JOINT COMPANY/UNION SAFETY COMMITTEE CONCERN FORM

Case No. 90-012

Concern (briefly) POSSIBLE CROSS CONNECTIONS BETWEEN AIR BORN RADIO ACTIVE CONTAMINATION AND DOMESTIC WATER SYSTEM THROUGH UNPROTECTED EMERGENCY SHOWER AND EYE BATH FIXTURE IN RADIO ACTIVE CONTROLLED AREA.
(THIS SAFETY CONCERN SHOULD HAVE IMMEDIATE ACTION)

RE: CLOSE-OUT OF SAFETY CONCERN NUMBER 90-012 / POSSIBLE CROSS CONTAMINATION

EXAMPLE

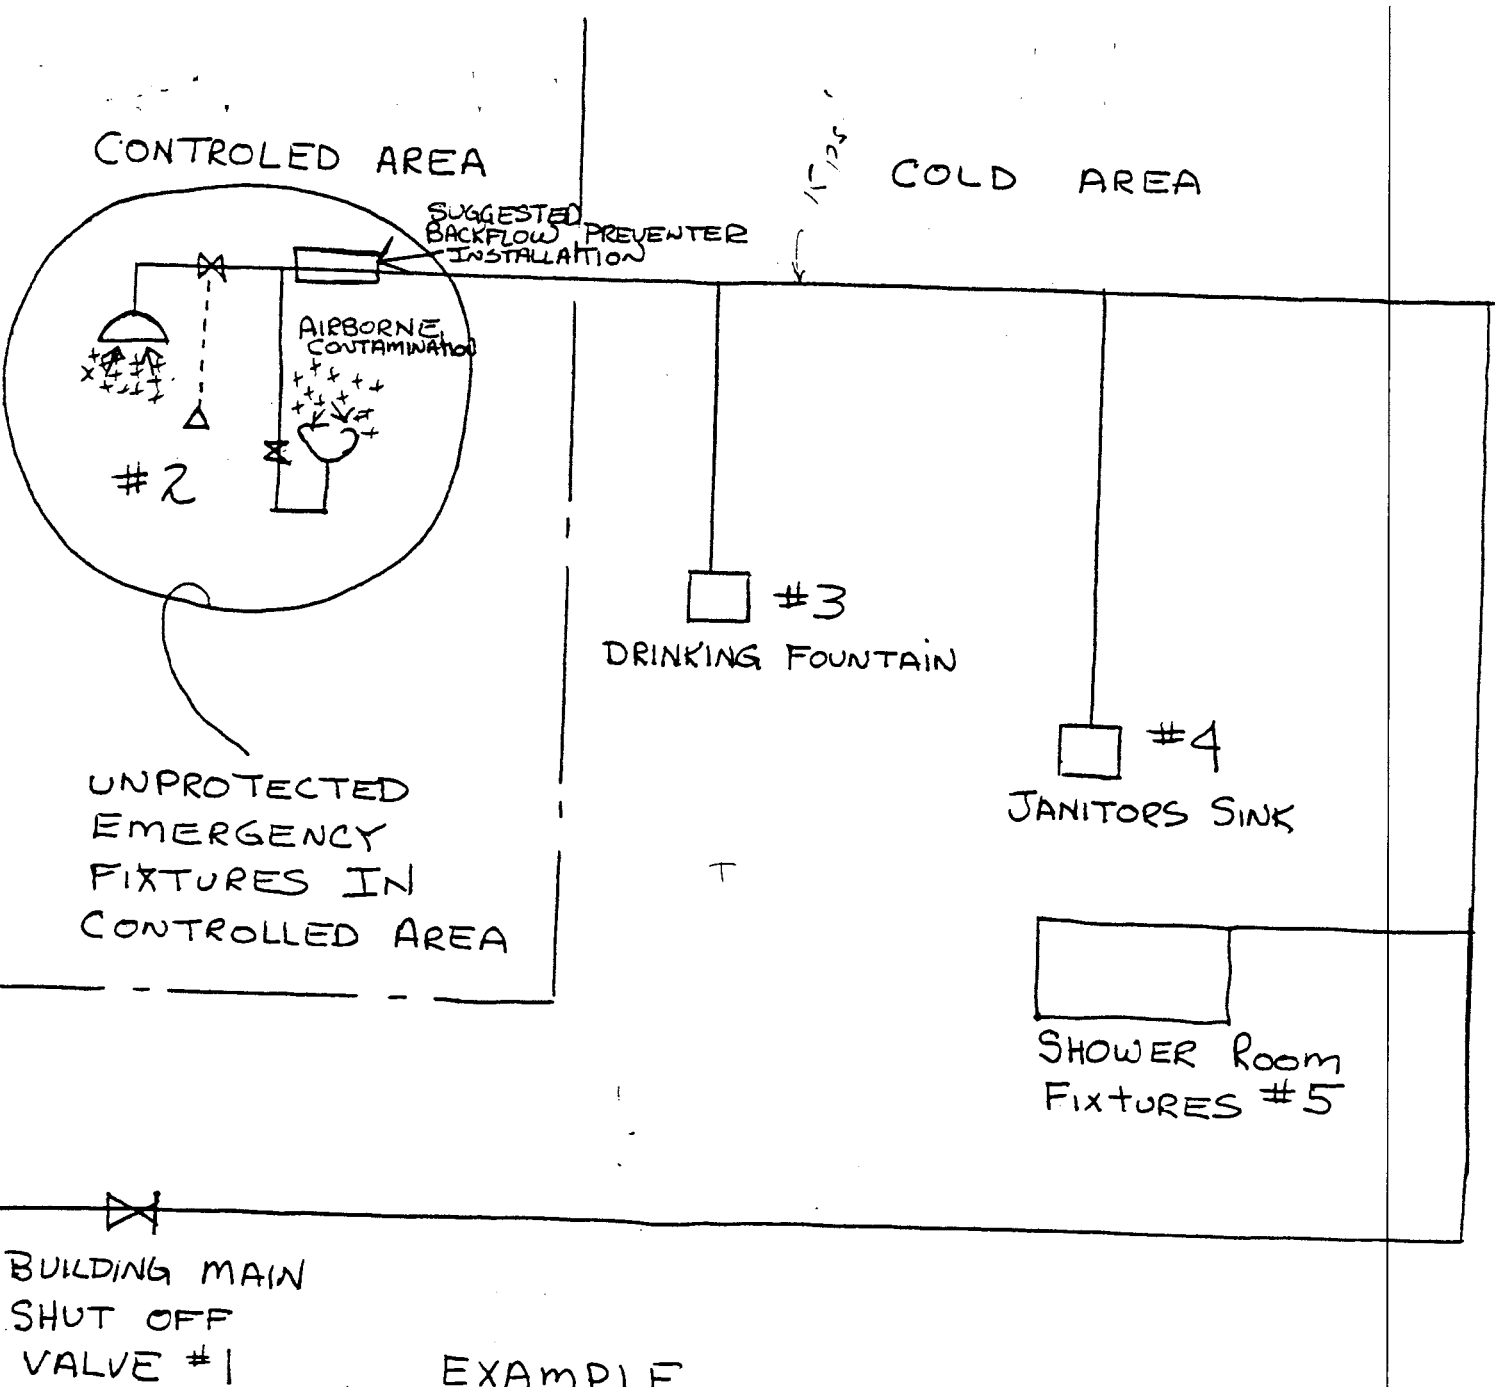
- ③ ANY LOWER FIXTURE (#3,4,5,) DRINKING FOUNTAIN, LAVATORY'S ETC, COULD DISCHARGE THE CONTAMINATED WATER WHILE DRAINING
- ④ WHEN WATER PRESSURE IS TURNED BACK ON (#1) TO THE SYSTEM THE CONTAMINATED WATER WILL DISCHARGE THROUGH DOMESTIC FIXTURES (#3,4,5) UNDER PRESSURE
- ⑤ CONSIDERING BUILDING WATER SYSTEMS ARE SHUT DOWN FOR ANY PURPOSES (REPAIRS, REMODELS, ETC) THIS TYPE OF CROSS-CONNECTION COULD OCCURE AT ANY TIME
- ⑥ LOCATION OF THESE EMERGENCY FIXTURES IN CONTROLLED AREAS ARE PLANTWIDE KNOWN EXAMPLES ARE:

- ⑦ AN APPROVED BACKFLOW DEVISE SHOULD BE INSTALLED PER INDIVIDUAL FIXTURE
- ⑧ IF YOU HAVE ANY QUESTIONS ON THIS SUGGESTION PLEASE CONTACT BUCK CHOI OR TED KOCOL AT 2720 OR 7839

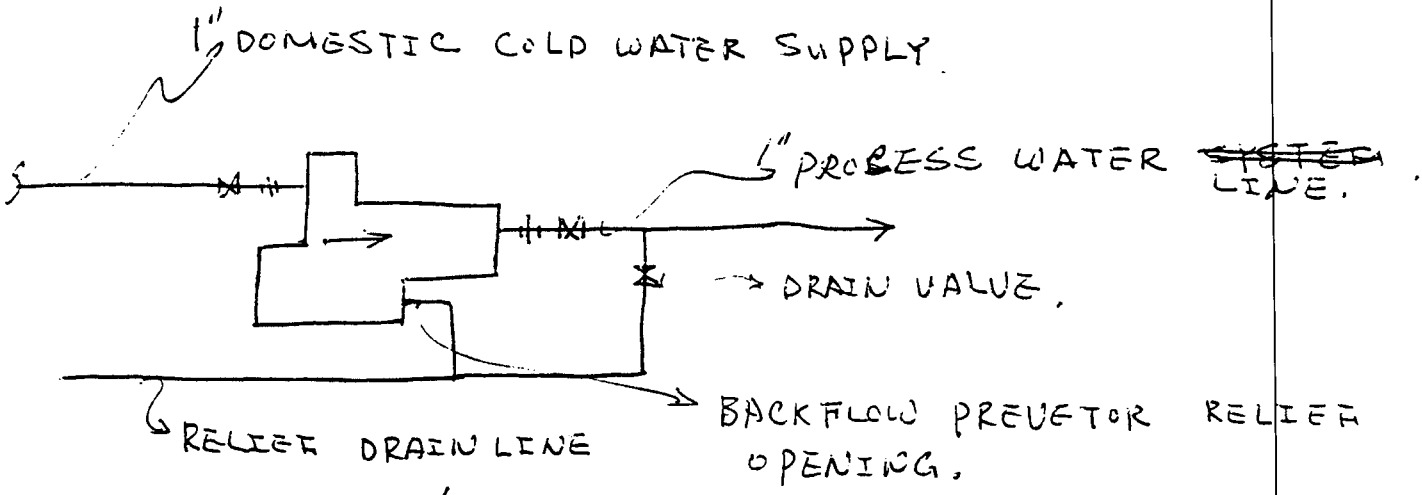
PROPOSED METHOD OR SOLUTION: REPIPE INSTALLATION OF BACKFLOW PREVENTER TO MEET COLO DEPT OF HEALTH REGULATIONS (SEE ATTACHED DRAWING)
